Title: UNAlink_BLUENRG2

Usage: UNAlink Module for Una Watch with BLE 5.2

1.0)	Design Completed	17/01/2024	Lewis Allison
1.1)	Engineering Change Note 1	02/02/2024	Lewis Allison
1.2)	Engineering Change Note 2	10/04/2025	Lewis Allison
1.3)	Engineering Change Note 3 (Layout Only)	17/04/2025	Lewis Allison
1.4)	Engineering Change Note 4	05/02/2026	Lewis Allison

EEPROM

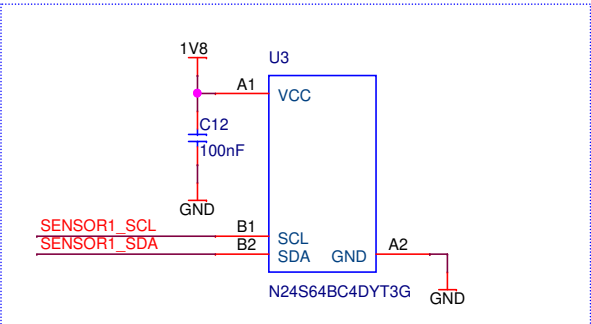
ECN 2:
U3 changed to N24S64BC4DYT3G

Test Points

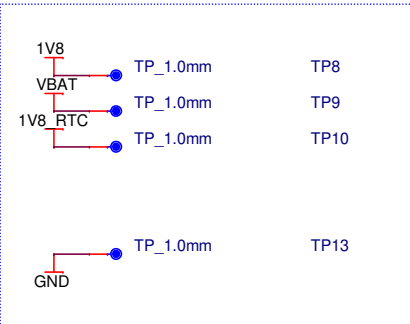
ECN 4:
Removed TP11 and TP12

ECN 4:
Added GND Pad.

BLE 5.2 Network Processor

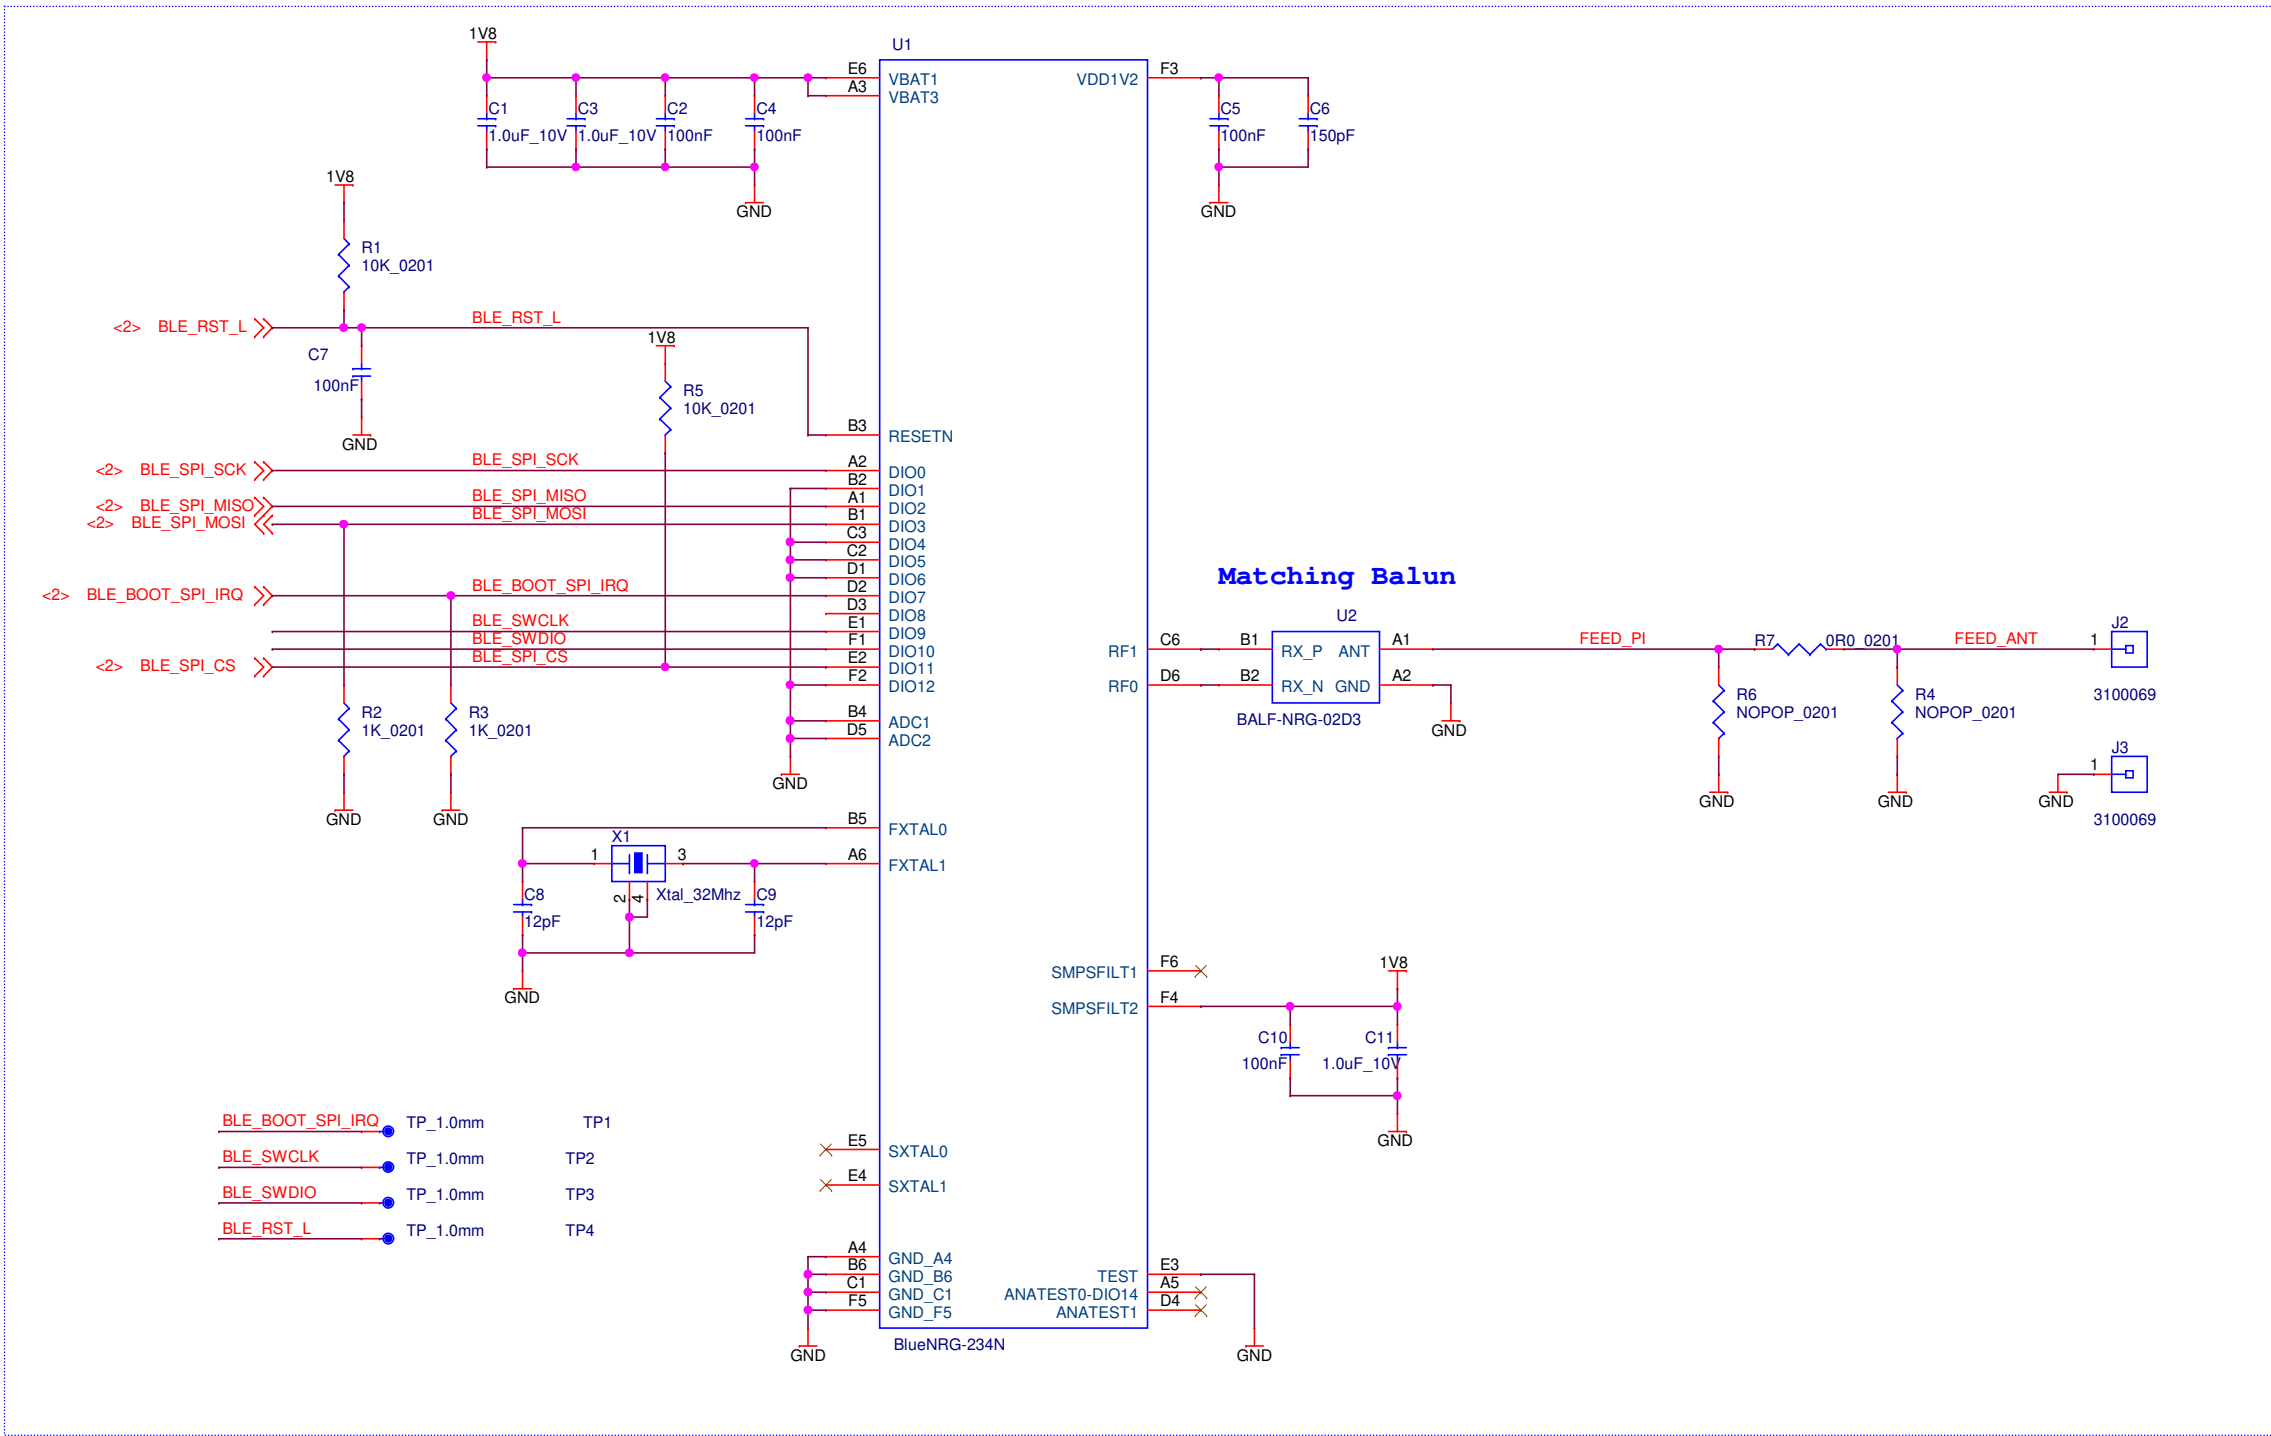
ECN 1:
C1, C3, C11 changed to GRM033R61A105ME15D (1uF_10V)
